***Return of Thunder Bay C1
Notification of Conditional Approval of Connection Proposal
CAA ID Number: 2007-EX372***

Return of Thunder Bay C1 (CAA ID Number: 2007-EX372)

ASSESSMENT SUMMARY**Ontario Power Generation****1.0 GENERAL DESCRIPTION**

Figure 1: Thunder Bay GS

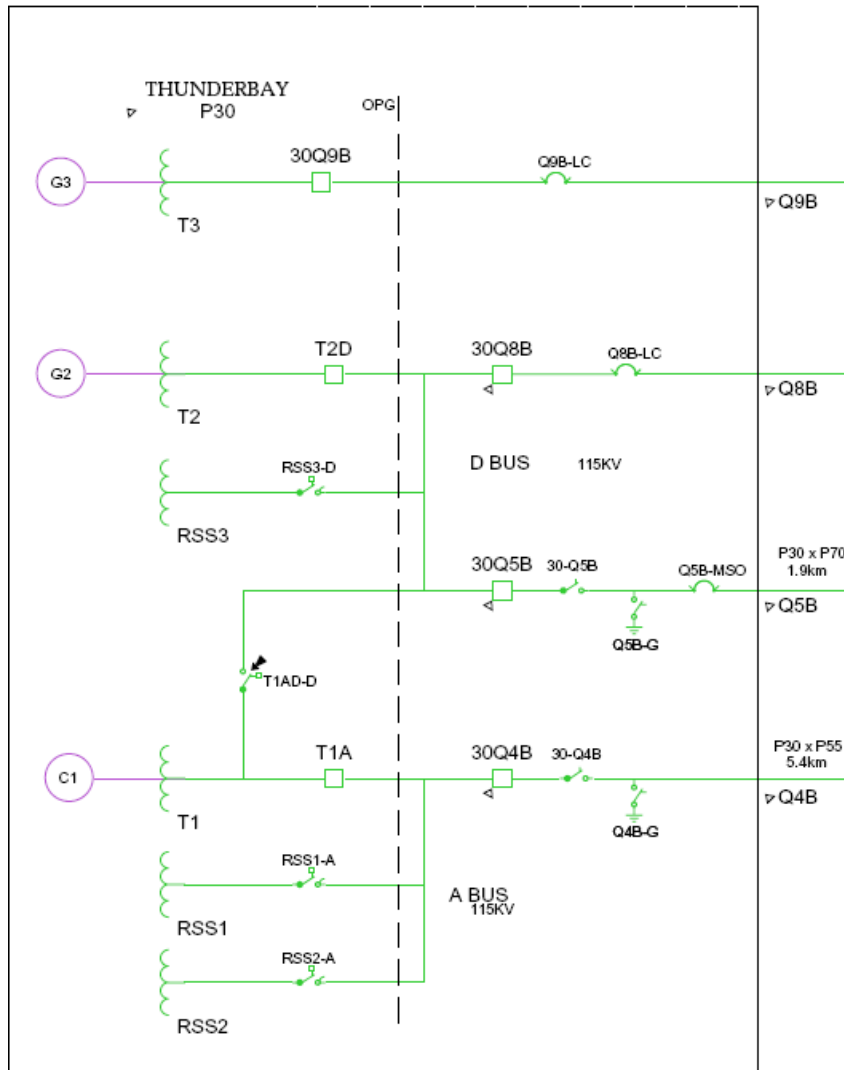
The information provided by OPG shows that the technical characteristics of the synchronizing condenser C1 have not been changed since the unit was removed from service one year ago. The single line diagram is shown in figure 1. OPG has confirmed that the connectivity and equipment ratings will remain unchanged.
